To: After Sales Official Network
Subject: Door gas spring fixing pin
Date: 22/07/2025
Pages: 4

L74X-R.01.25

Door gas spring fixing pin

Revuelto

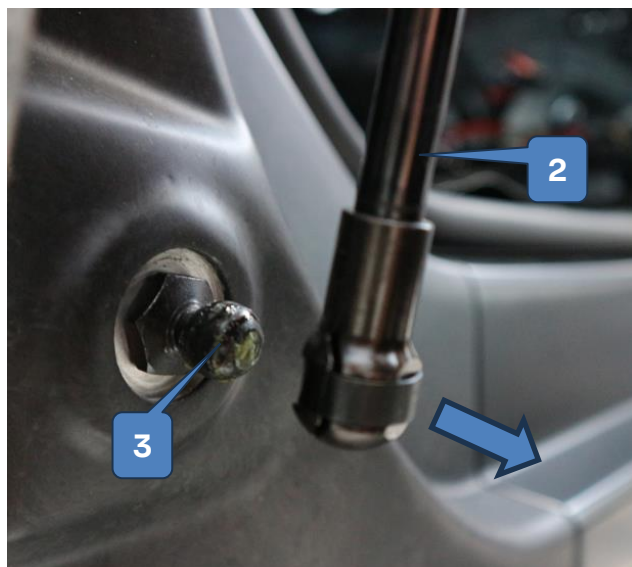
During ongoing product monitoring, Automobili Lamborghini S.p.A. identified a potential issue on some vehicles and has released a new mandatory update for the potentially affected cars for the verification of the correct tightening torque of the door gas spring spherical pin.

Check and, if necessary, tighten door gas spring fastening pin

2. In the lower area, open the safety catch (1) of the gas spring (2) using a screwdriver and move it slightly backwards.
3. Release the gas spring (2) from the fixing pin (3).
4. Check the tightening of the fastening pin (3), (tightening torque $24\text{Nm} \pm 10\%$ - 5.39lbft). If it is not tightened correctly, tighten it to the prescribed tightening torque of $24\text{Nm} \pm 10\%$ (5.39lbft).
5. Once the tightening has been checked, reposition the gas spring (2) on the fixing pin (3) and then close the safety catch (1).
6. Carry out the same procedure on the other door.
